FIFTH FLOOR PLAN PROPOSED

EIGHTEEN SUNSET
1759 PURDY AVE
MIAMI BEACH, FLORIDA
07/16/18

ROOF DECK PLAN PROPOSED

VALET DIAGRAM

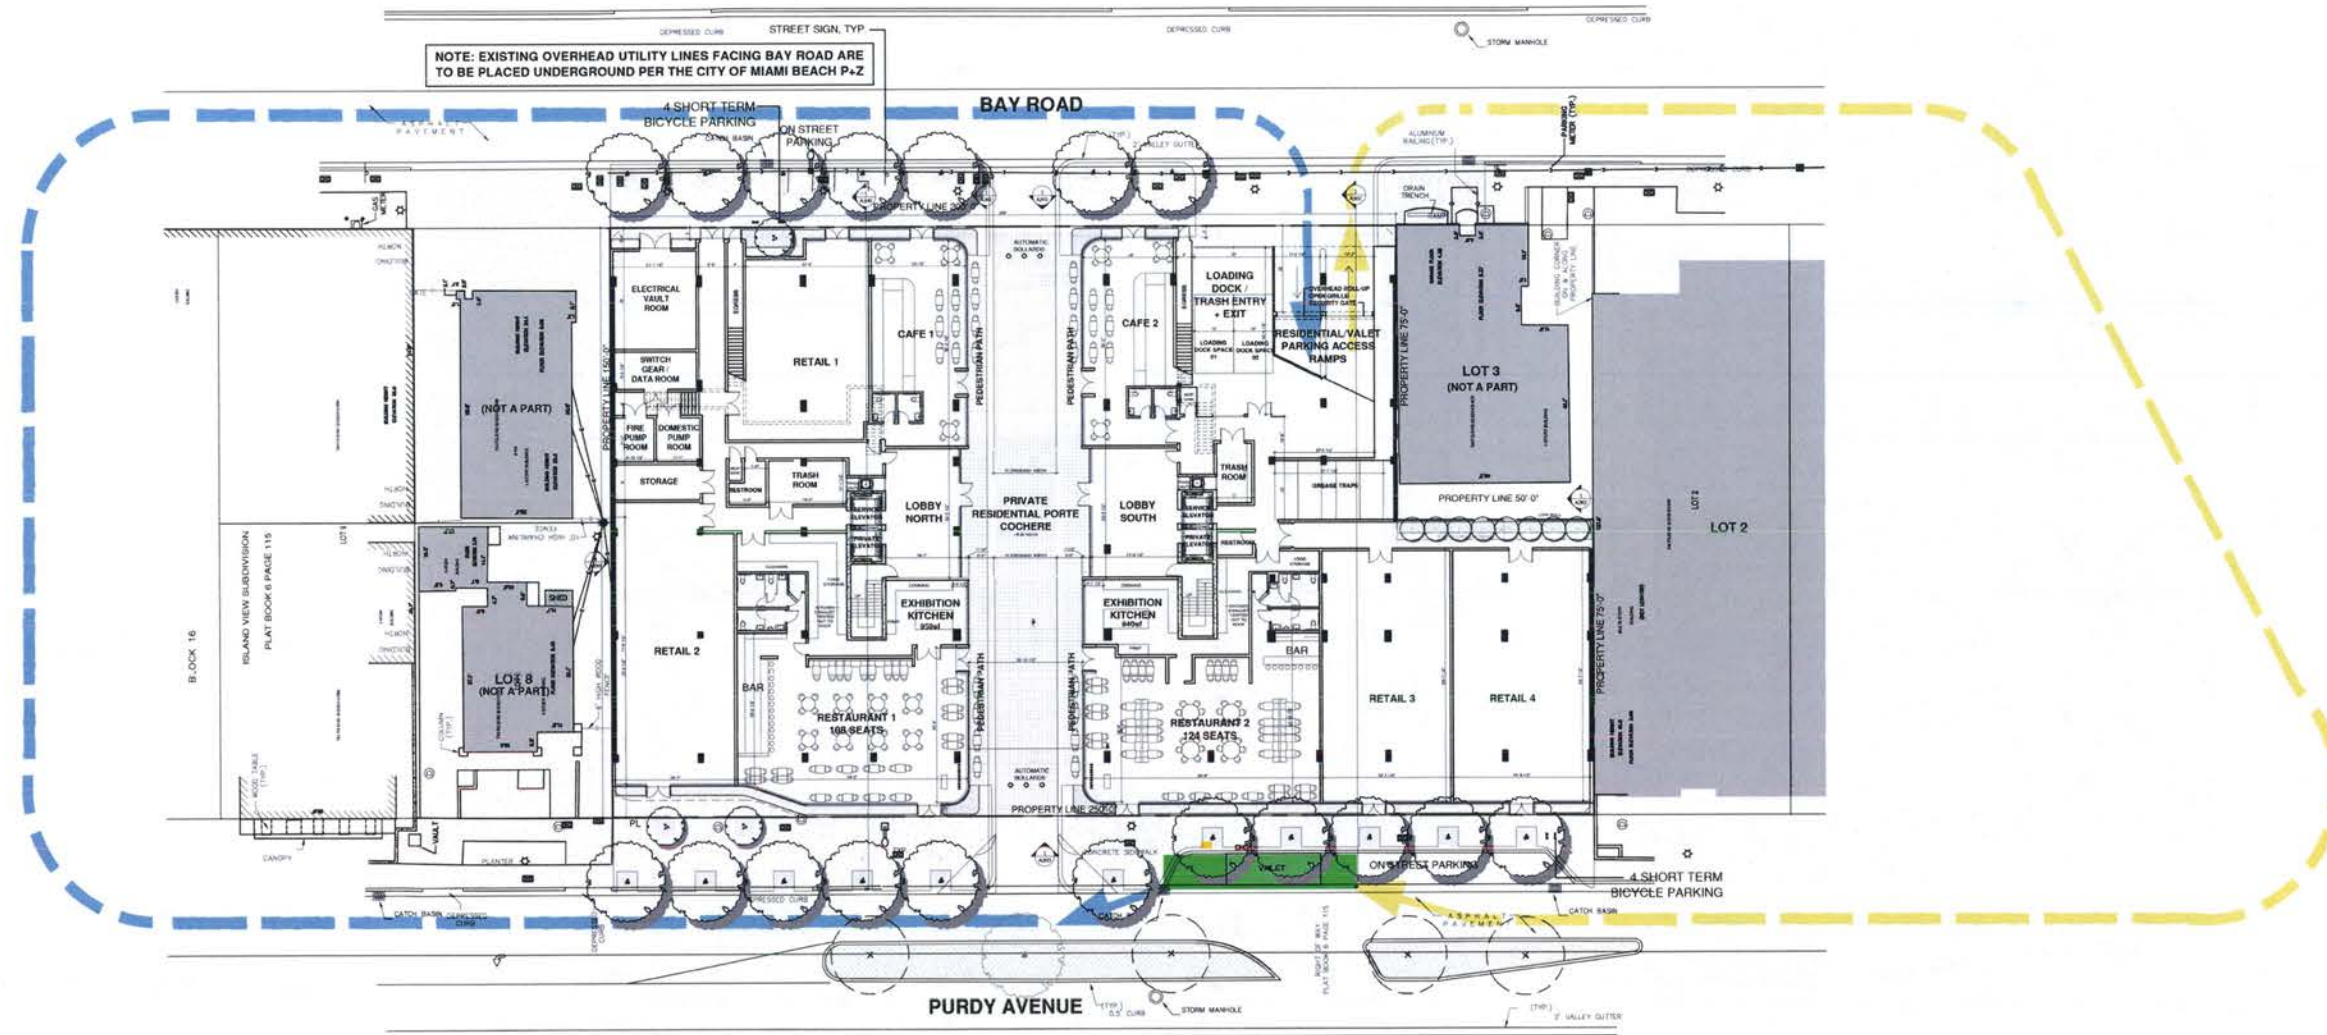
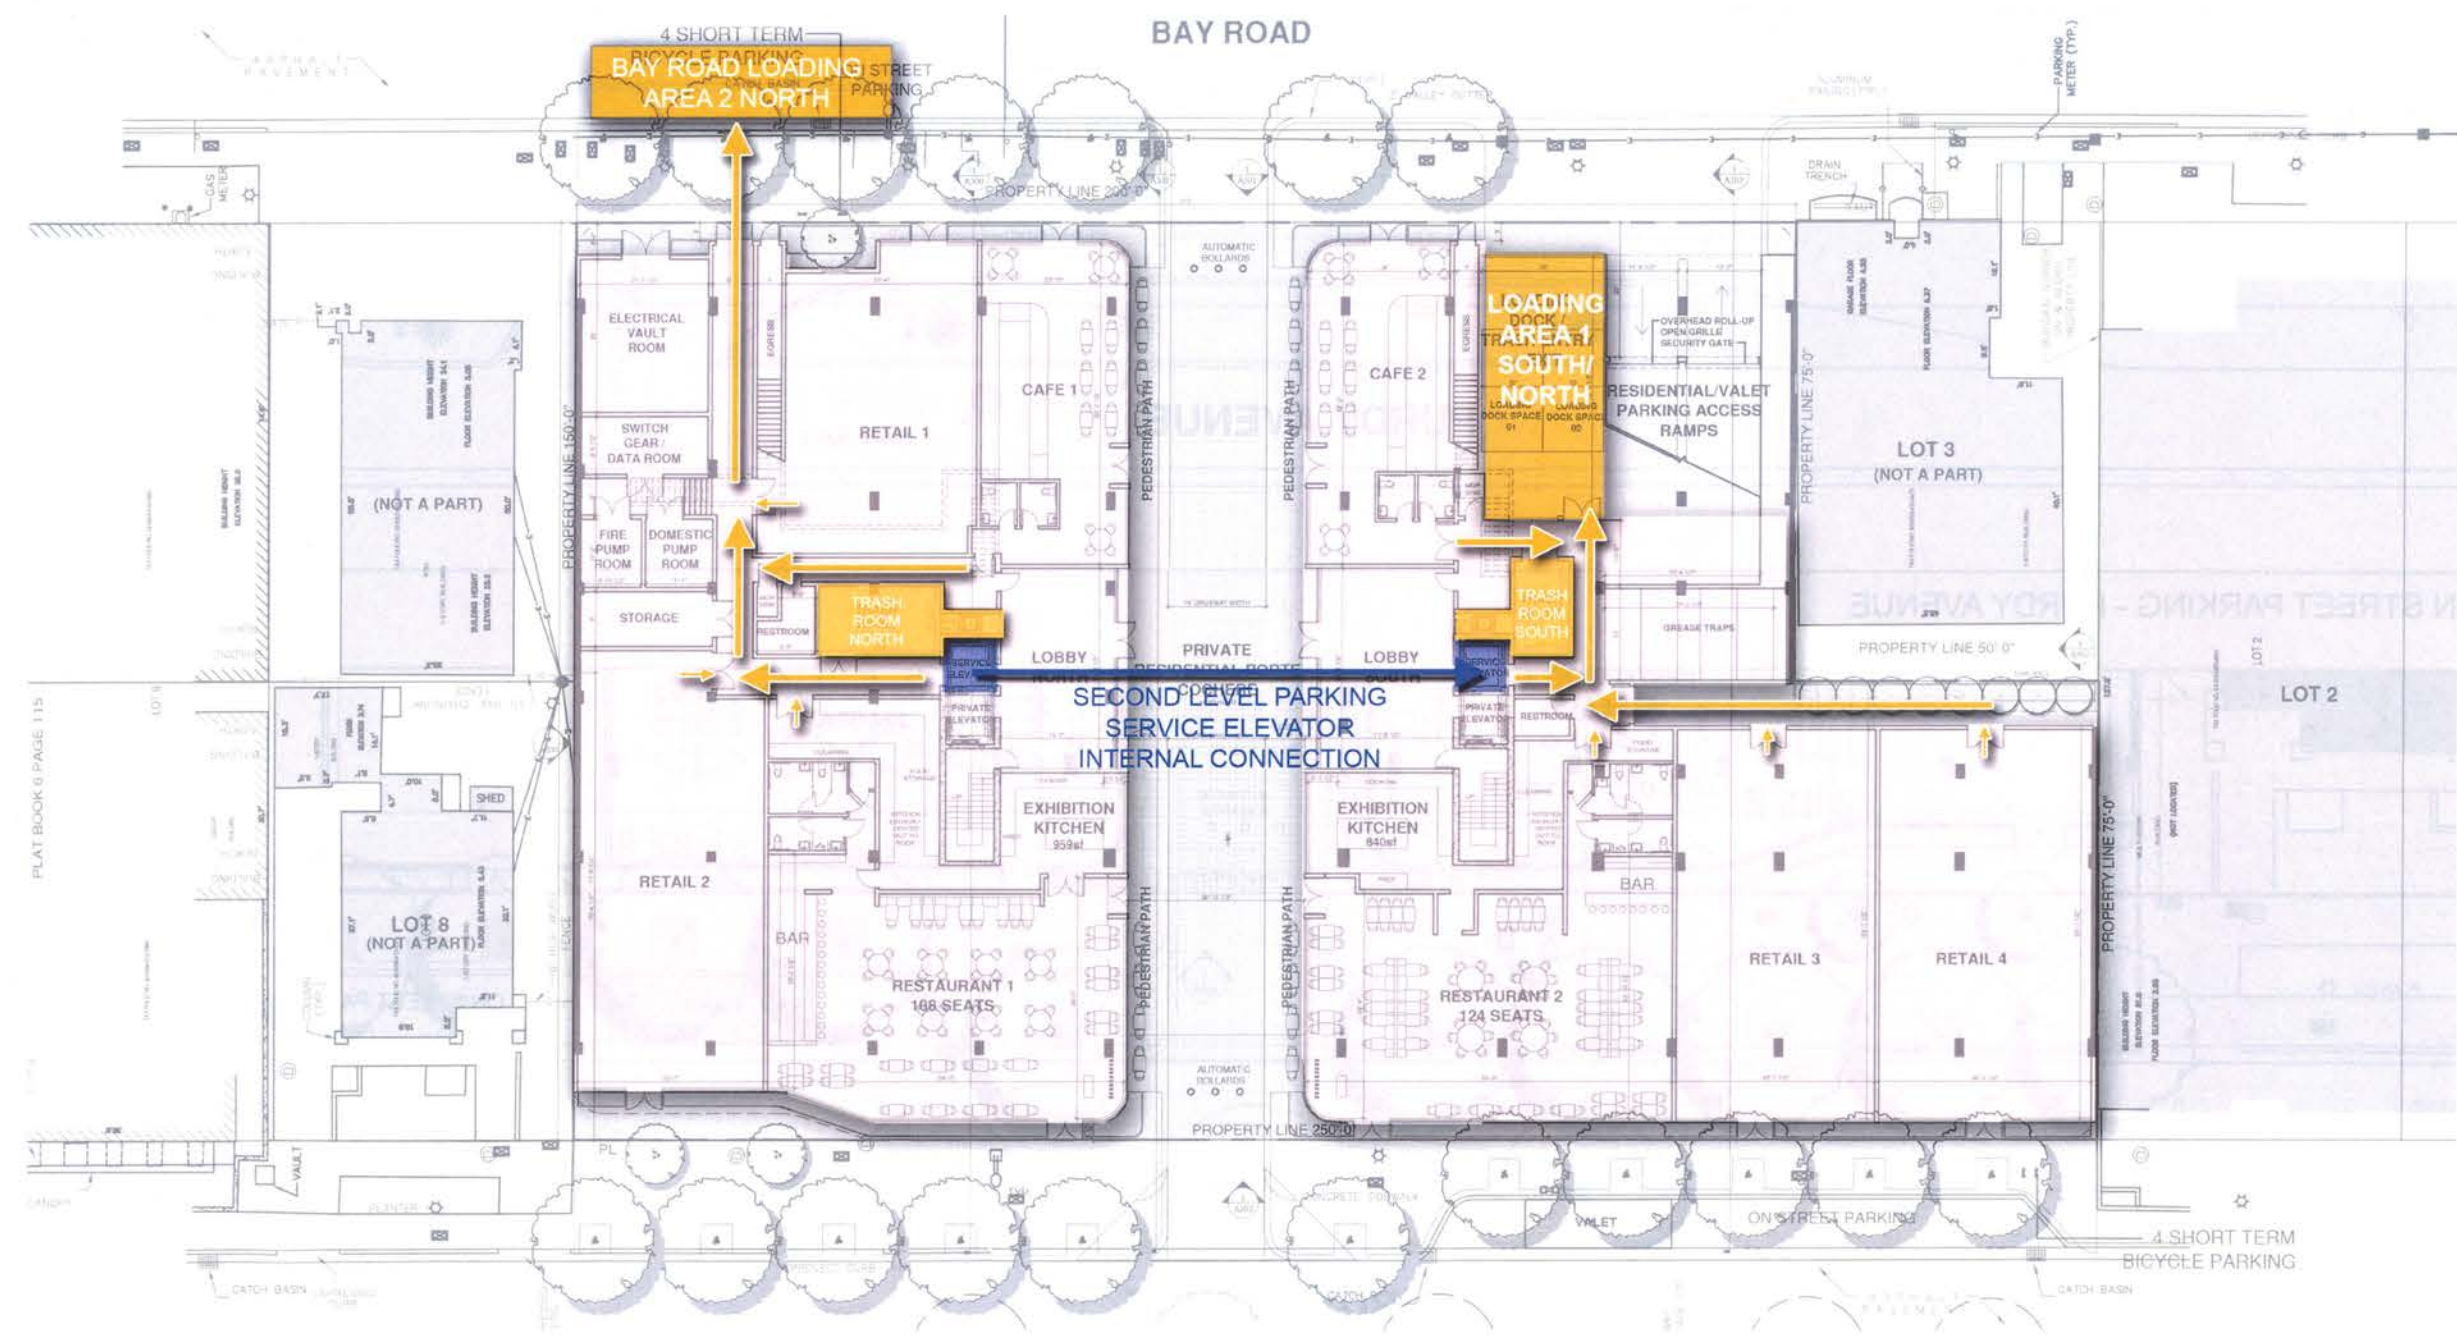
NO VALET NEEDED PER NEW PROPOSED DEVELOPMENT PROGRAM.
